Your Ref
Y/80/18/PL
Our Ref
PLAN-025552
Date
13/12/2018

Proposal: Change of use from cowshed to separate residential unit - This is a departure from the development plan.
Site: 1 Church Farm Cottages, Church Road, Yapton, BN18 0EP.
Y/80/18/PL

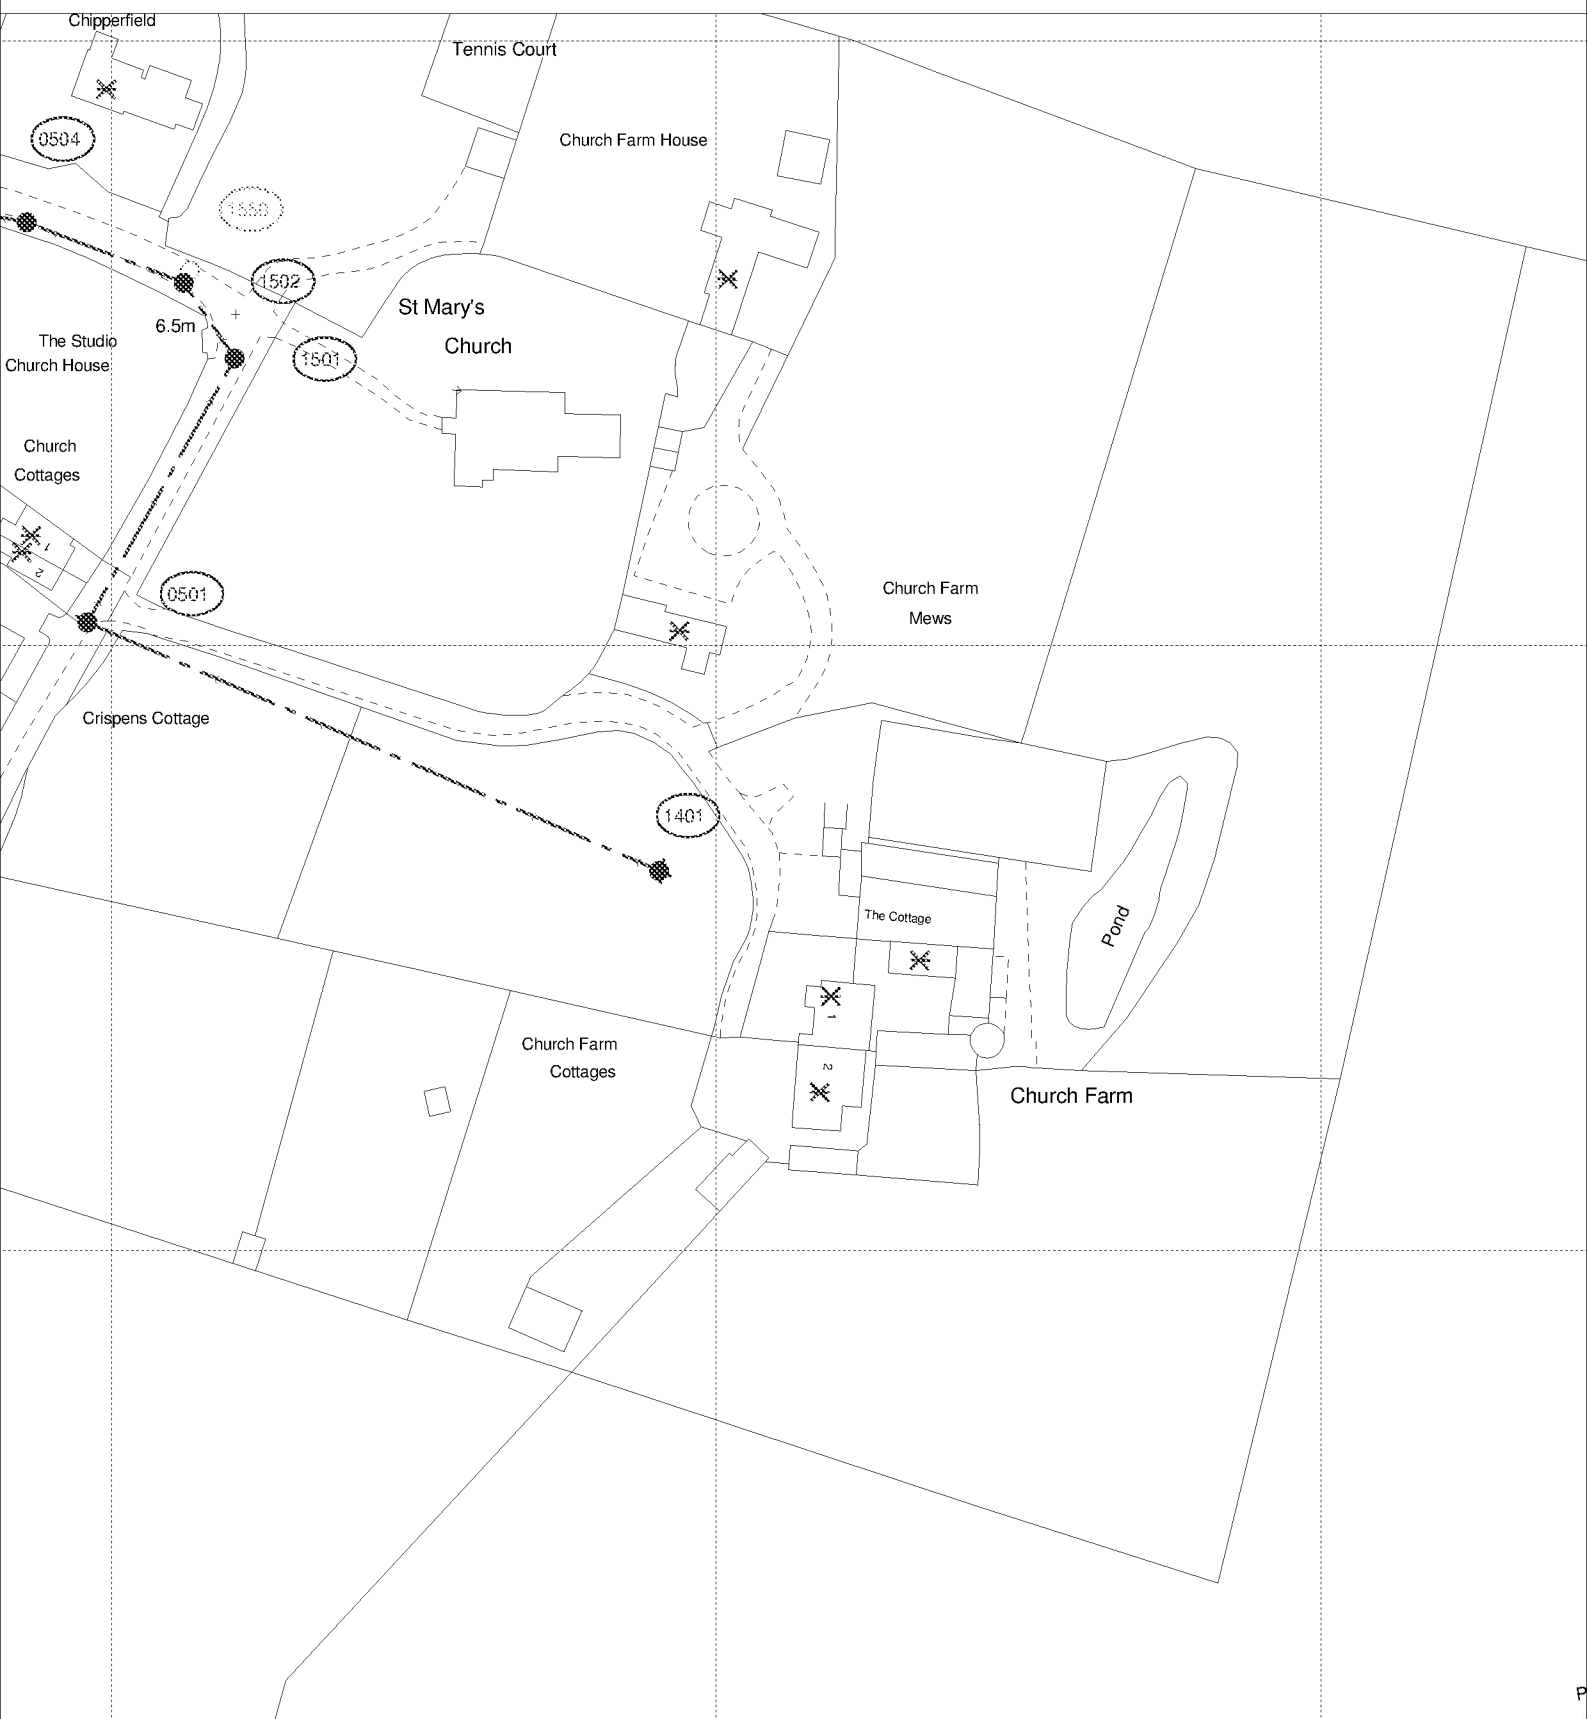
Due to surface water inundation issues in the Lidsey Catchment "The applicant is advised to adopt, where appropriate, the measures in the table "Practical measures to reduce the potential impacts of development".

Developer should look to protect the public sewerage system from inundation and infiltration, which contribute to flooding in unfavourable conditions.
